## LiDAR Quality Assessment Report

### SD\_Missouri River Lidar Dewberry\_2016\_D16 - Block 8

NGTOC  
2018-06-18  
Sarah Klaas

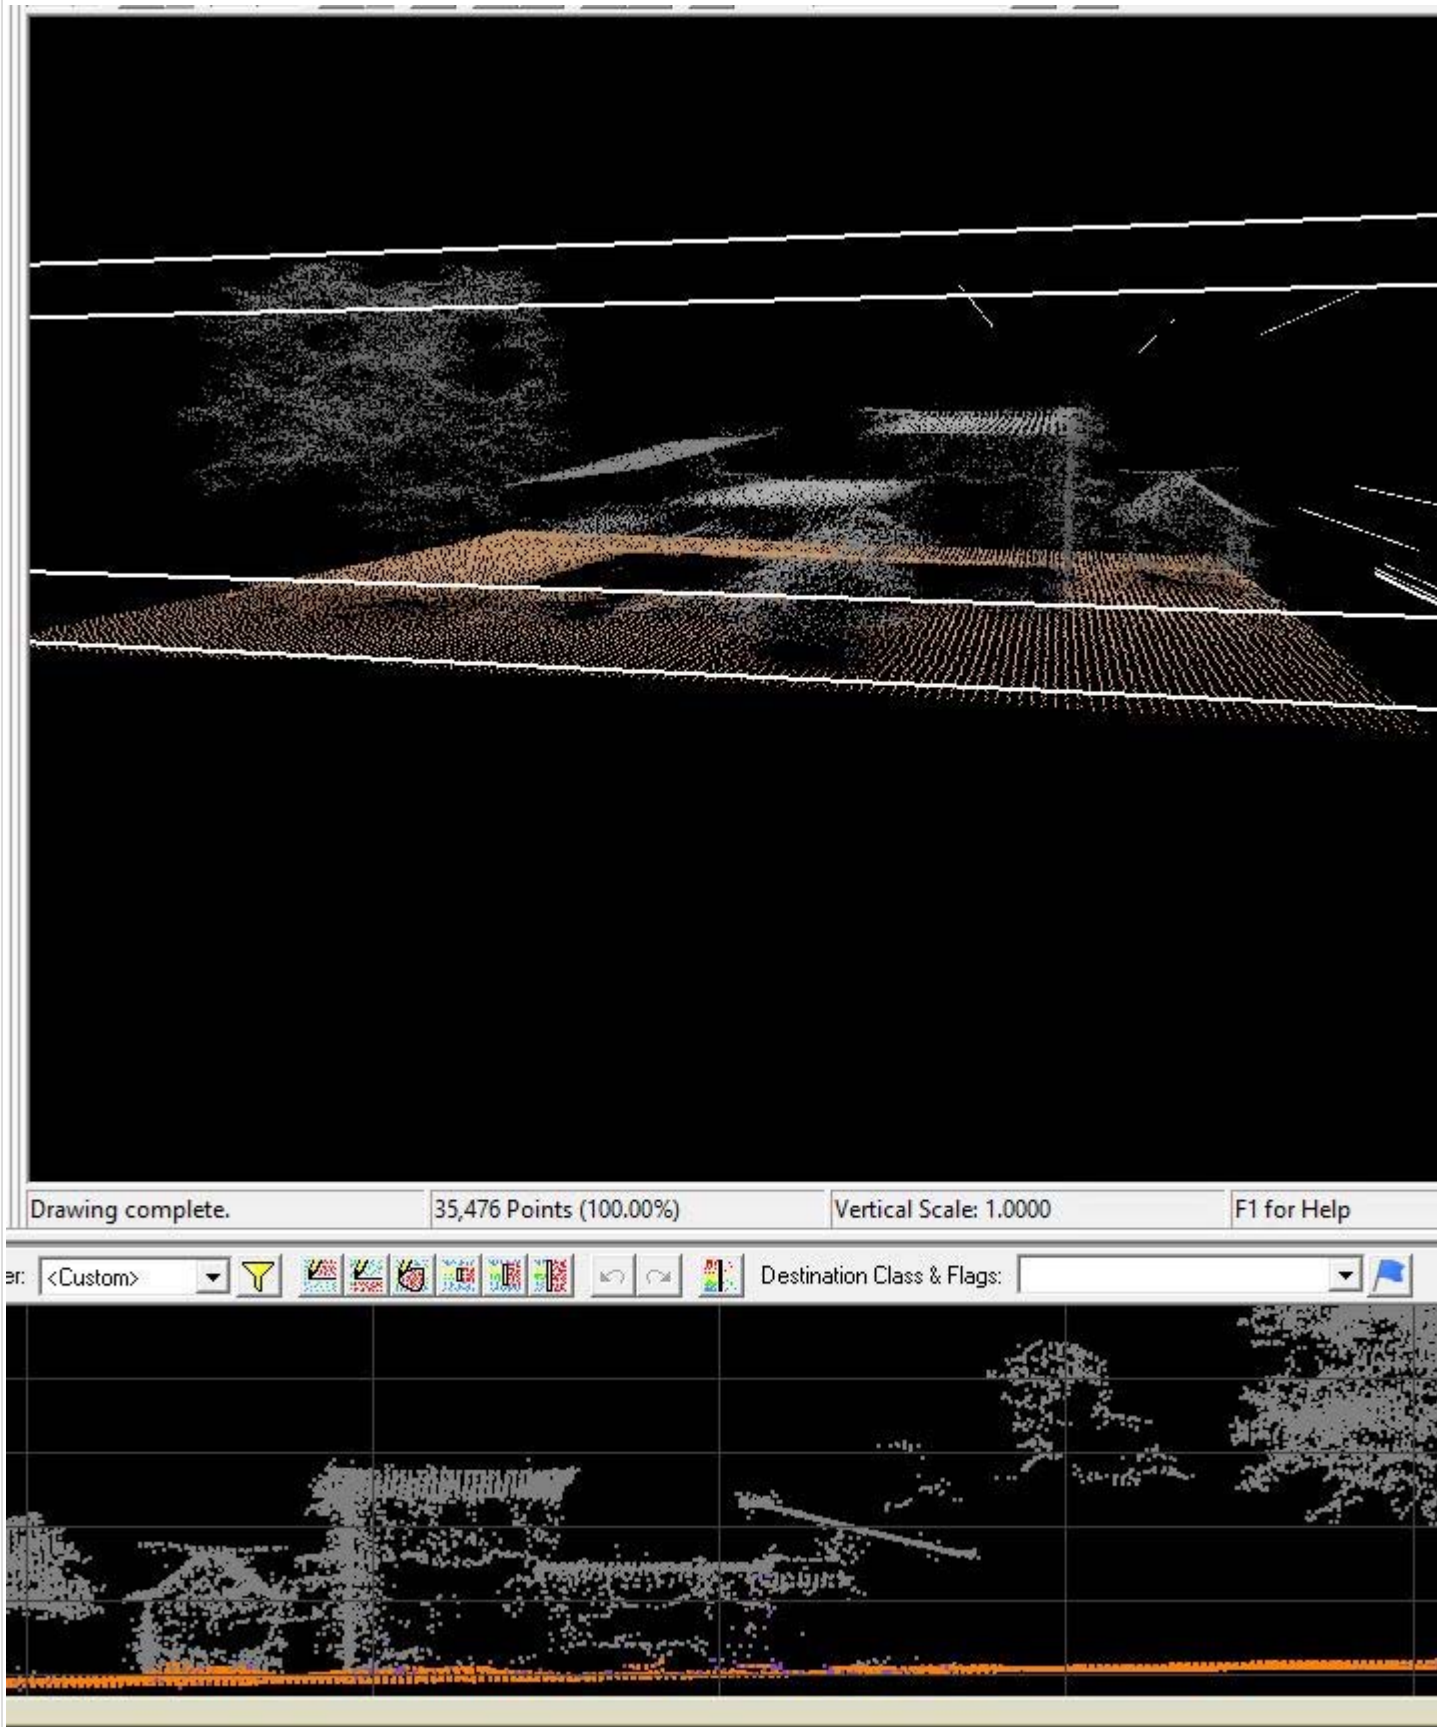
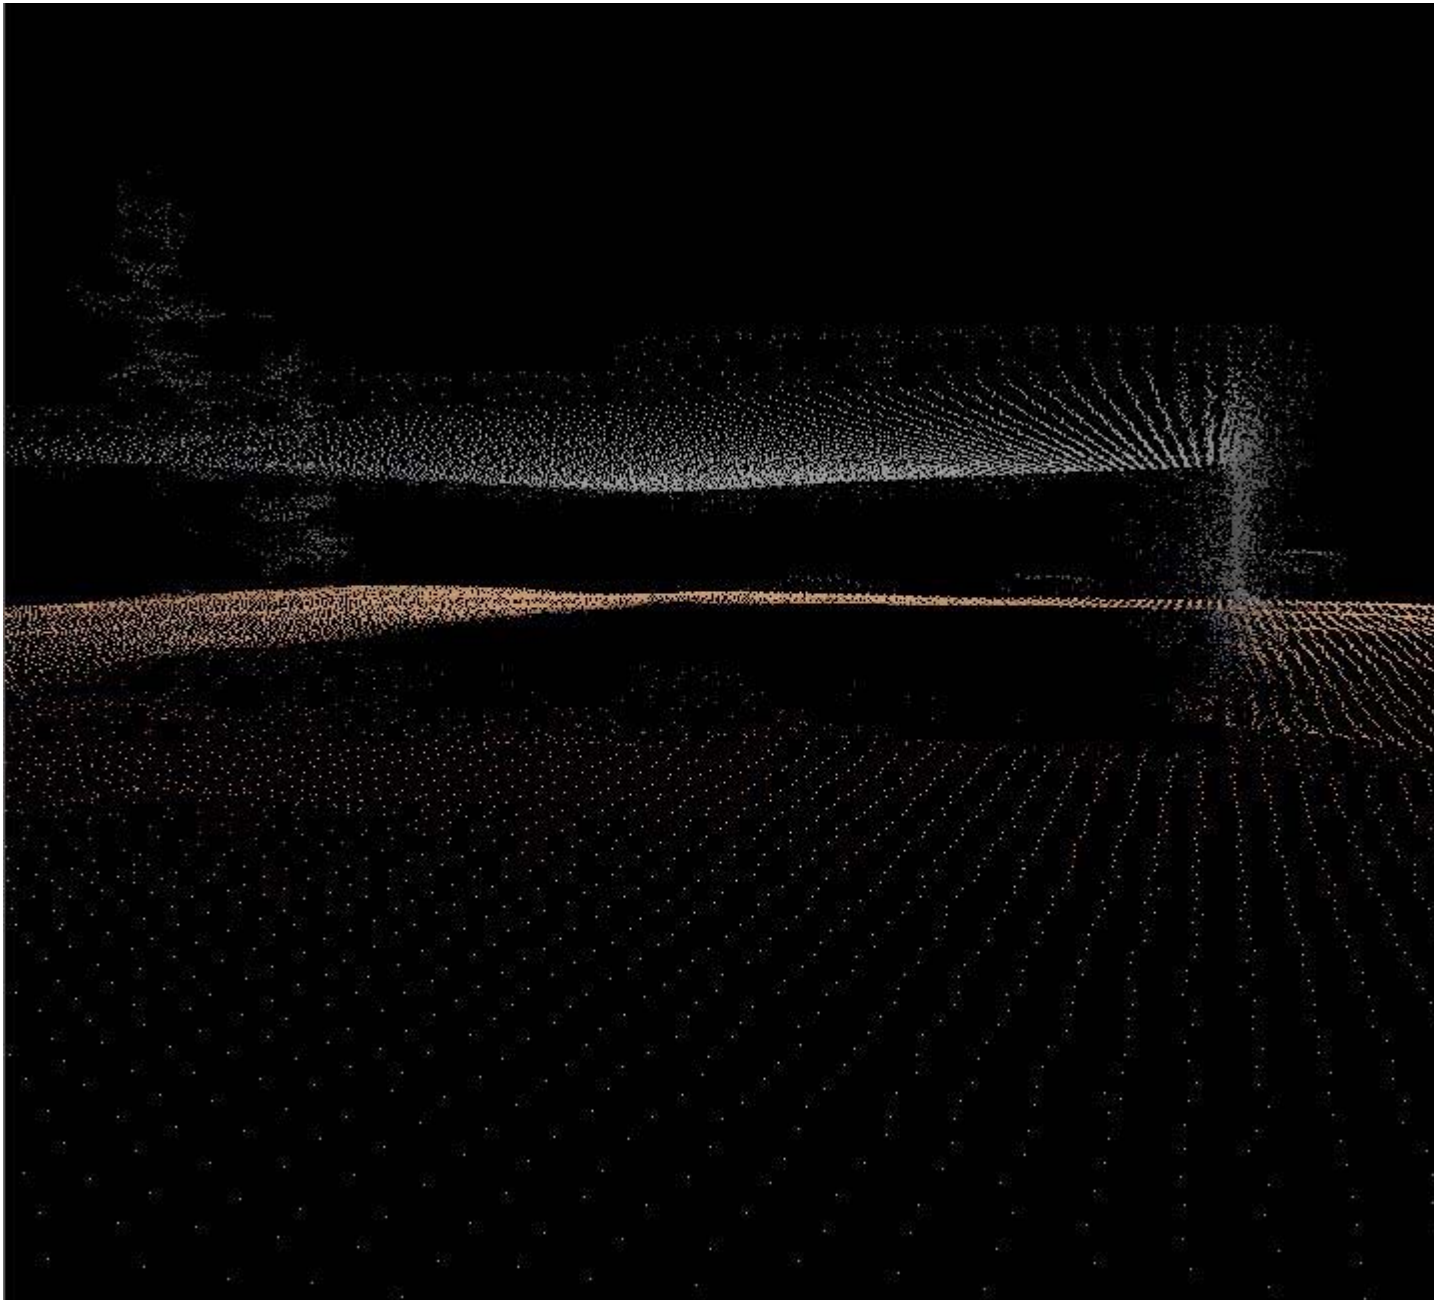
Examples of vertical wall structure scatter from the geiger mode sensor

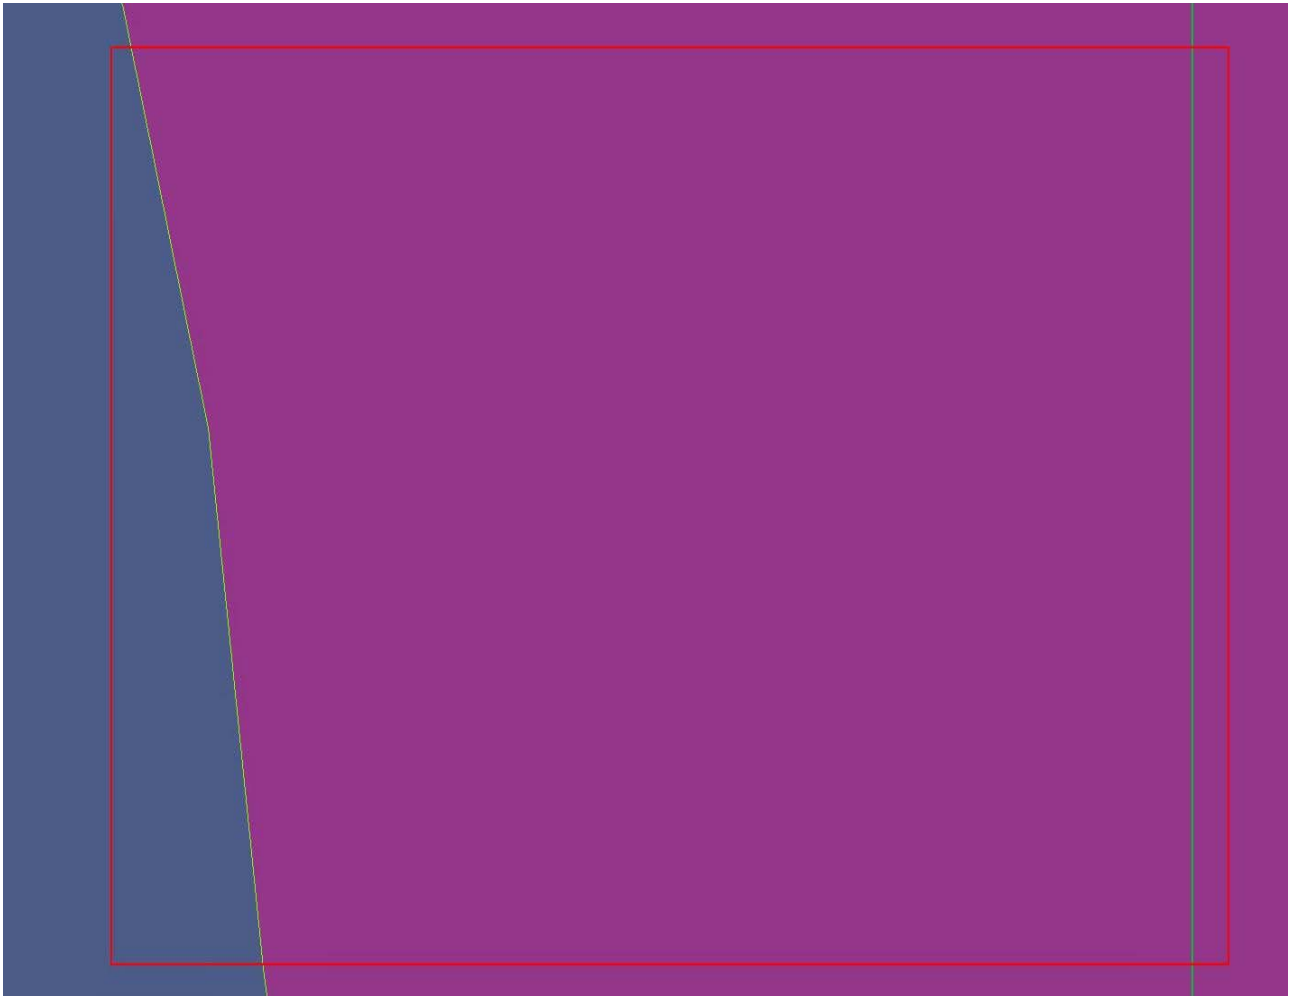
**Data does not extend out to the project boundary along the Eastern and Southern extent of Block 8. (6/18/2018)**

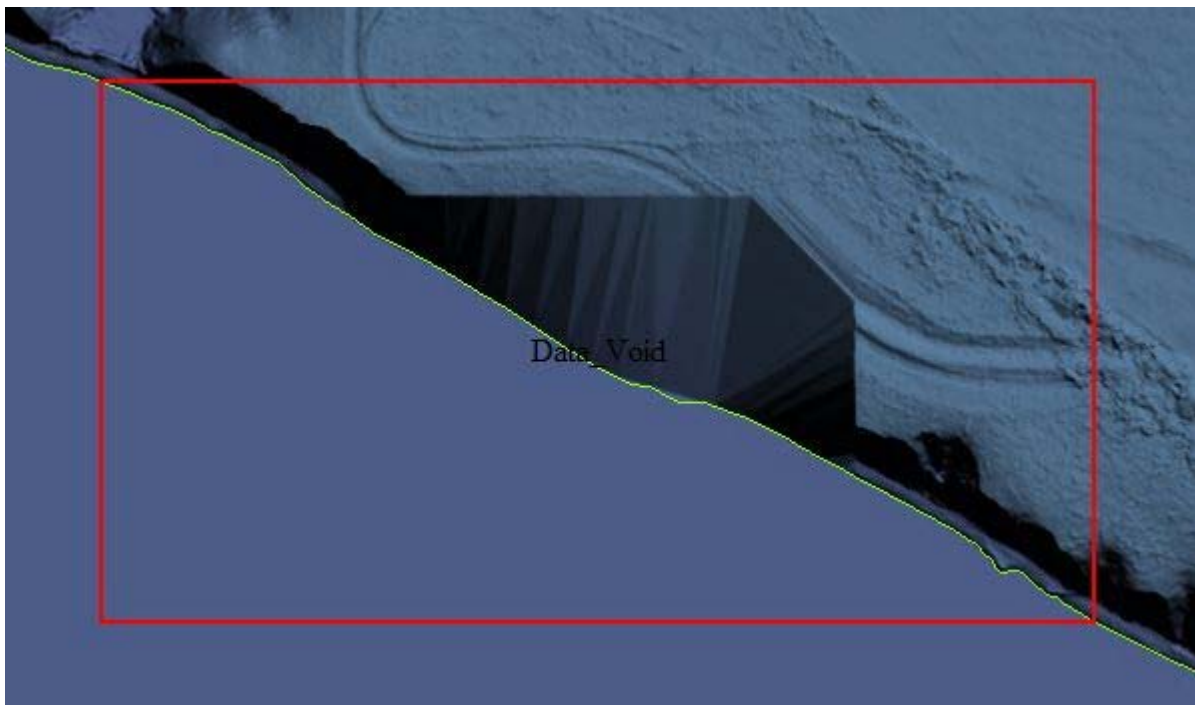
One data void along a lake in block 8 was found. (6/18/18)

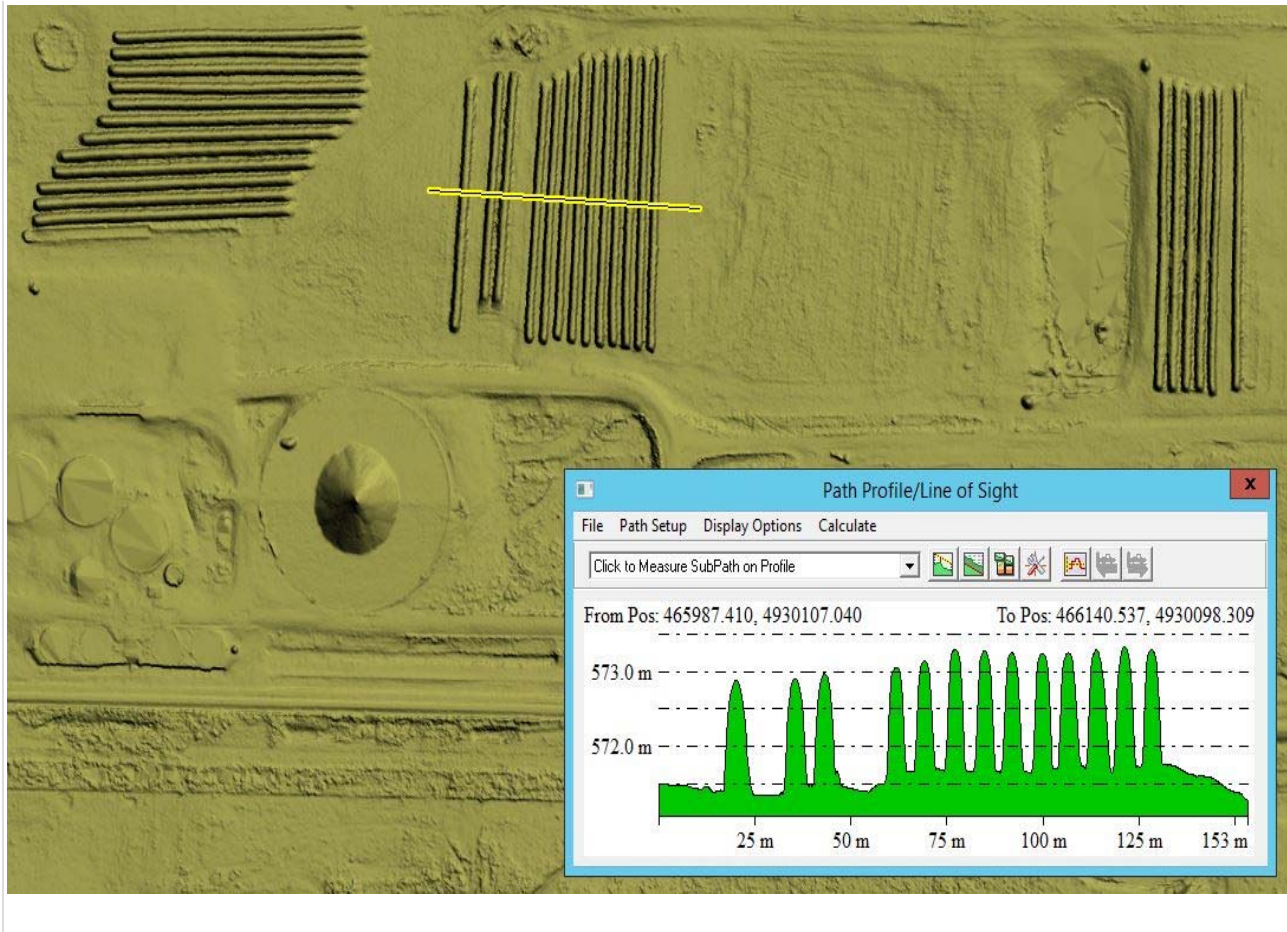
2 hydroflattening errors were found in block 8, waterbodies greater than 2 acres are not hydroflattened. Examples of this type of error can be seen below. (6/18/18)
